M42 Junction 6 Development Consent Order

8.71 Supplementary Environmental Appraisal Report on the proposed non-material changes

Supplementary Environmental Appraisal Report on the proposed non-material changes

Regulation Number	Rule 8(1)(k)
Planning Inspectorate Scheme Reference	TR010027
Document Reference	8.71
Author	M42 Junction 6 Project Team & Highways England

**WORKS PLANS
REGULATION 5(2)(J)
SHEET 2 OF 7**

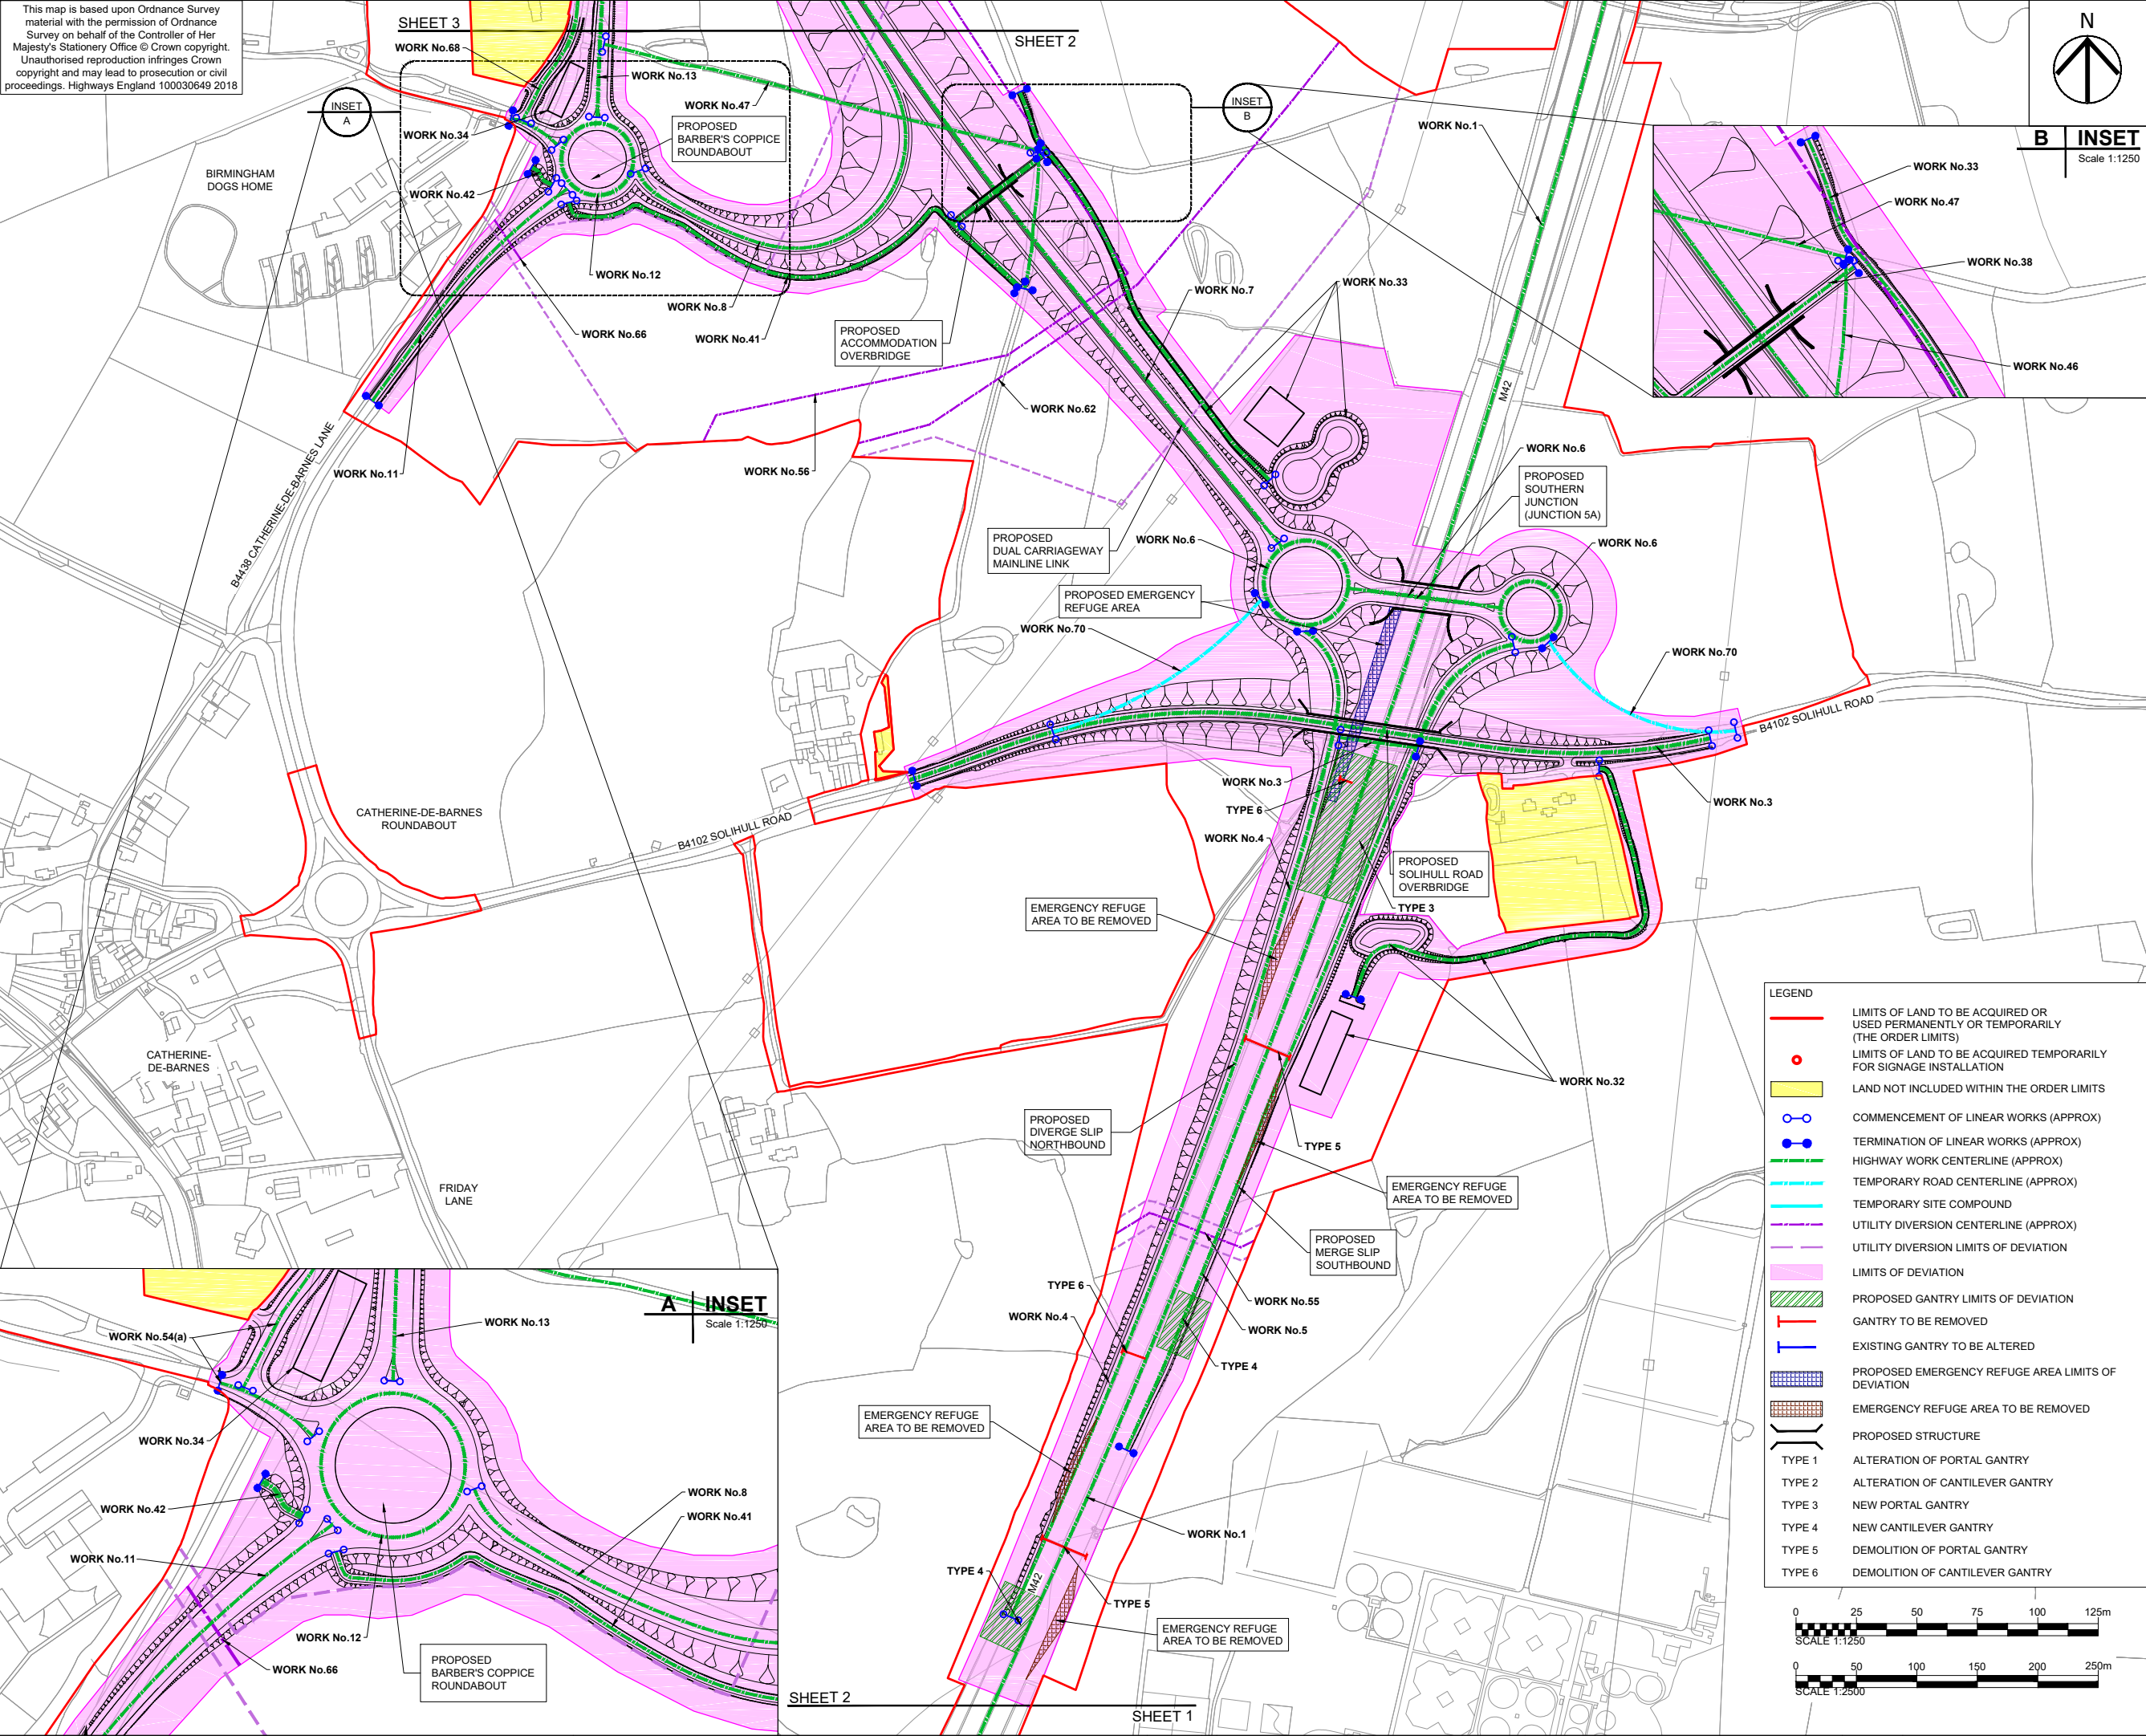
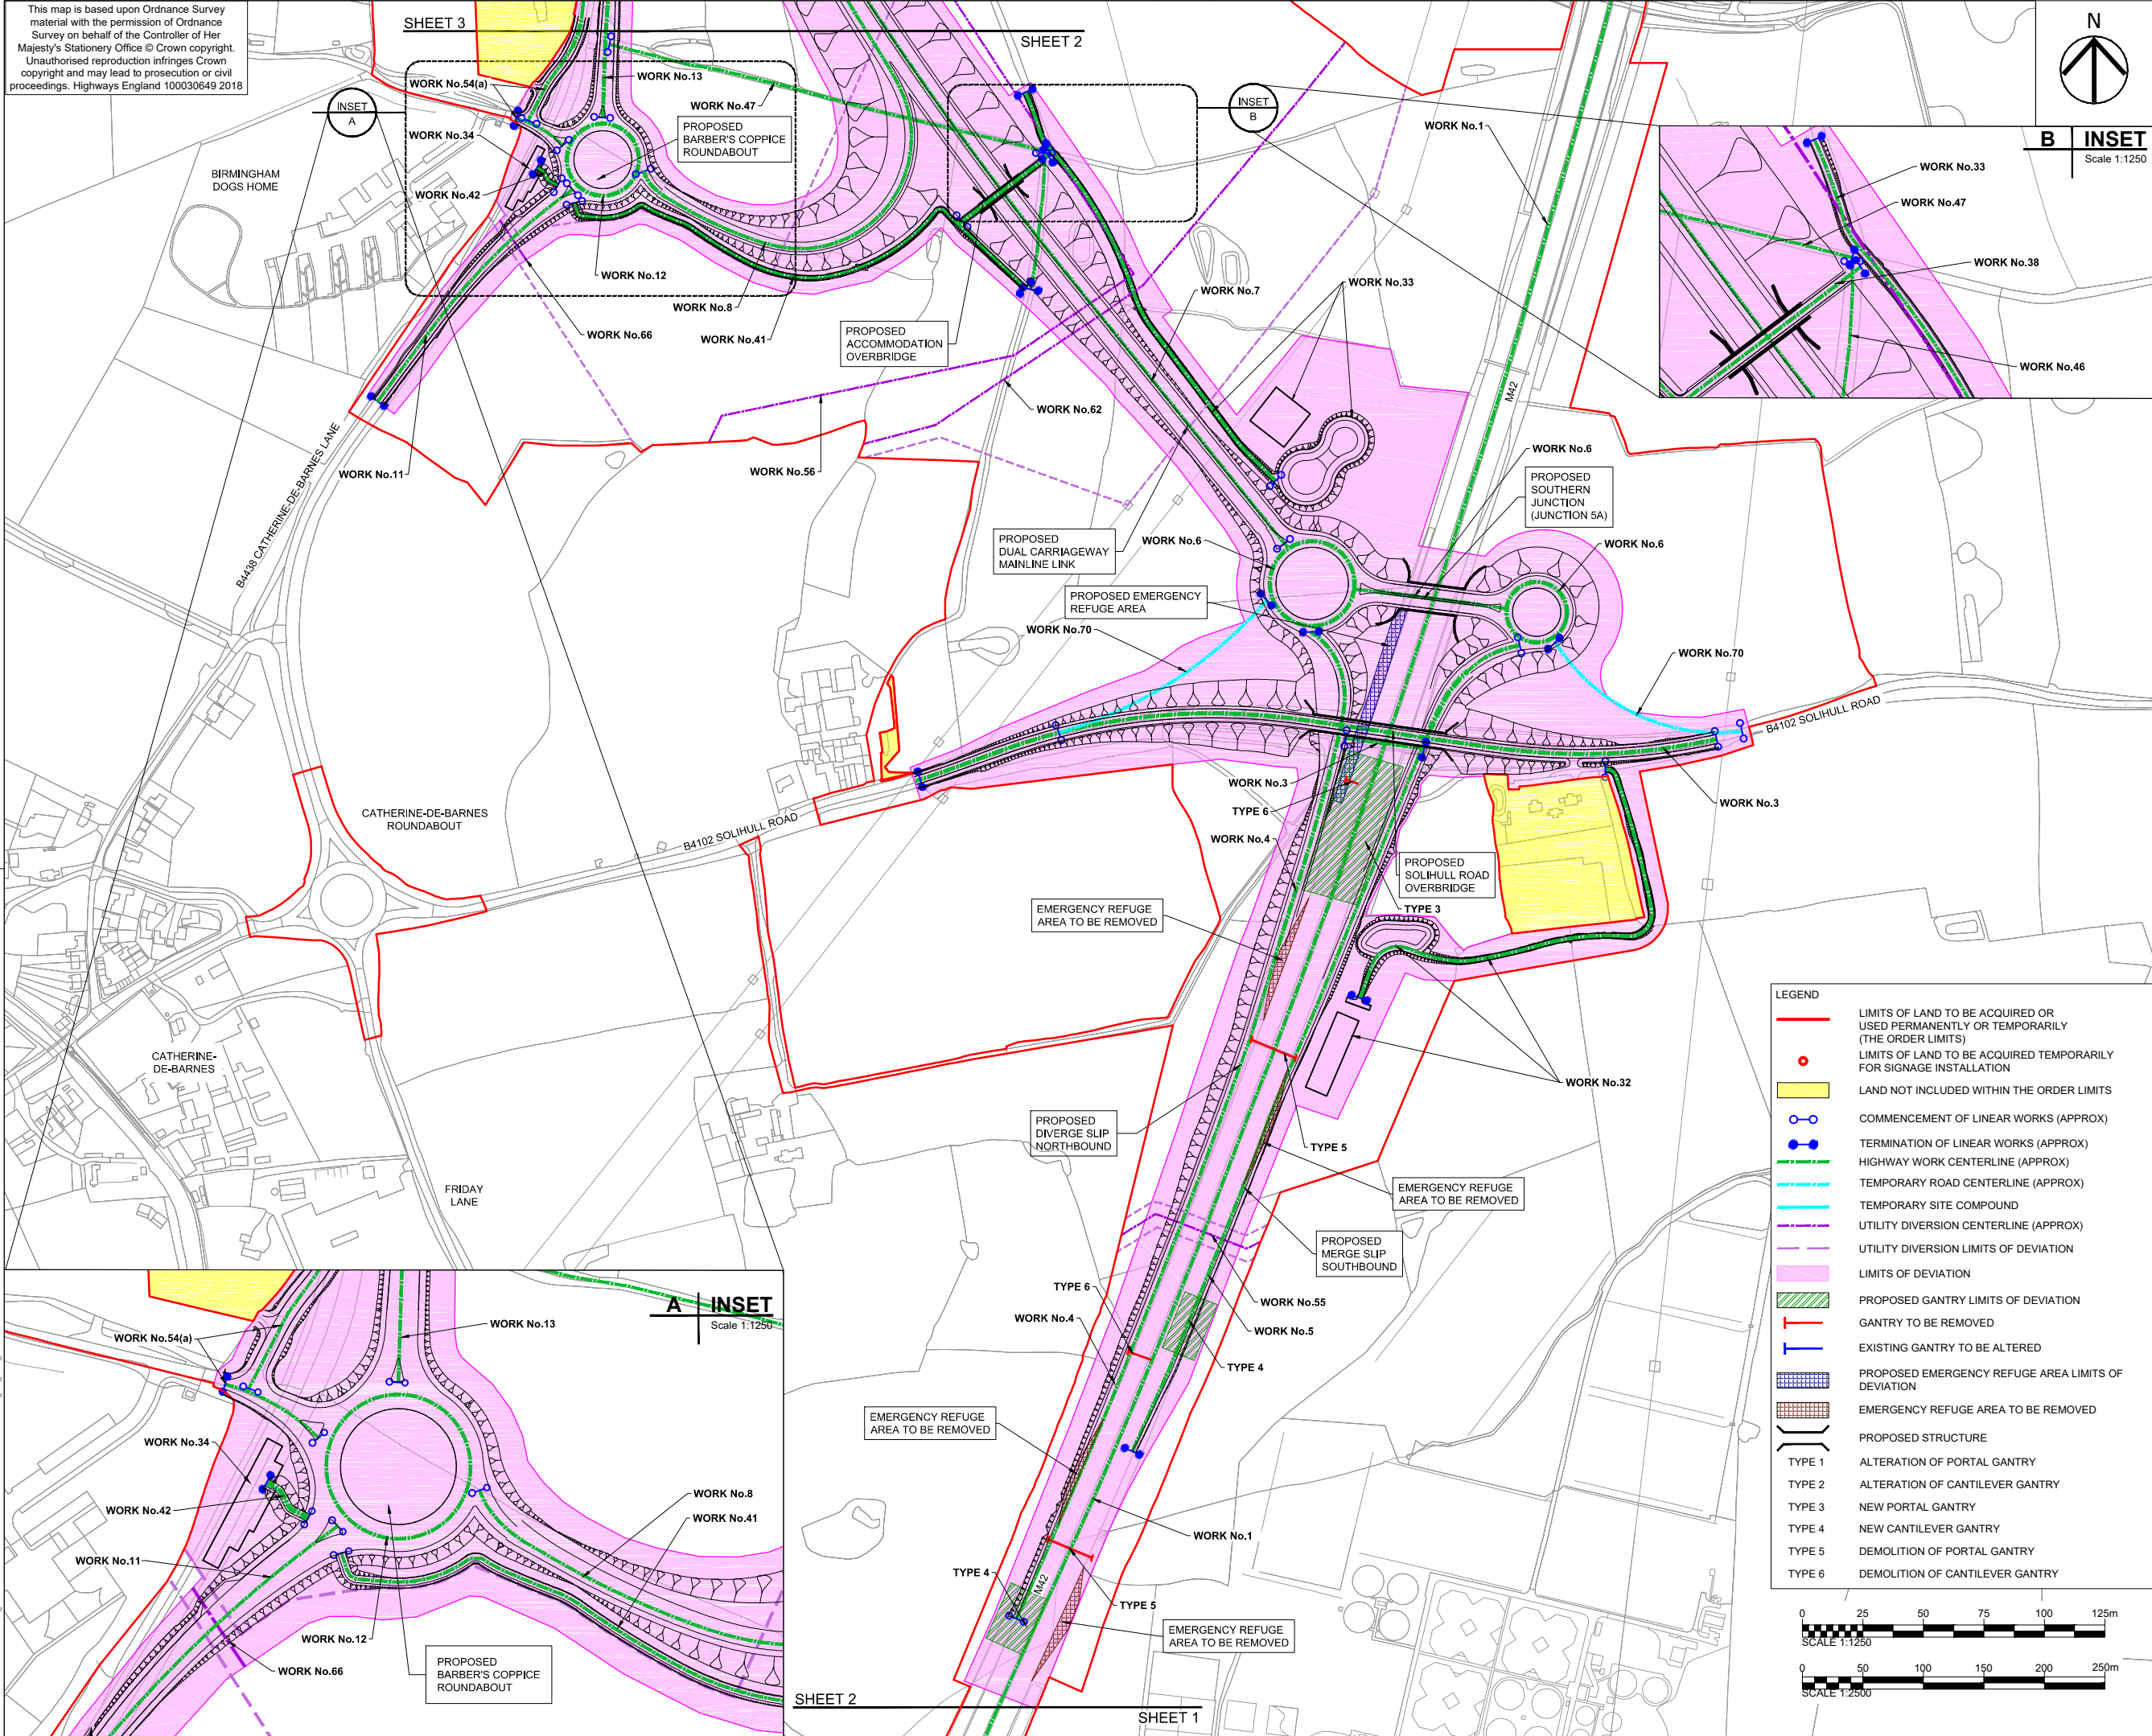
5 Change 2: Attenuation tank relocation (Work No. 34)

- 5.1.1 Following discussions with landowners and the local parish council, it is also proposed to change the location of, Work No. 34 (see Appendix D), a highway drainage attenuation tank, from the north western quadrant of Barber's Coppice Roundabout to the south western quadrant (see Appendix E). The proposed attenuation tank would require periodic maintenance in order to ensure that the attenuation tank continues to work at optimum performance. This periodic maintenance would require a vehicle to park near to the attenuation tank in order to enable personnel to access, inspect and maintain the tank.

- 5.1.2 In its existing location, the provision of a layby off the B4438 Realigned Catherine-de-Barnes Lane would be in close proximity to Barber's Coppice Roundabout where vehicles are leaving the roundabout travelling northbound. This location raises the following safety and operational concerns for the positioning of a maintenance layby:

- 5.1.3 As a result, the Applicant has proposed to move the attenuation tank to an area of land (parcel 2/10j and part of 2/71) (see Appendix F) which are already proposed to be acquired permanently to create new highway land, although they are outside the current LoD for Work No. 34.

- 5.1.4 The location has been proposed to mitigate the issues raised above by moving the attenuation tank south of Barber's Coppice Roundabout, where traffic would be decelerating on approach to the roundabout. Furthermore, the northbound lane on approach to the roundabout would expand to two lanes, reducing the risk of maintenance vehicles turning into a layby interfering with northbound traffic approaching the roundabout.

First Issue	WC	07/08/19	P01
Update to Work No.34 and Limits of Deviation	JCH	08/08/19	P02
Revision Details		By	Date
		Check	Suffix
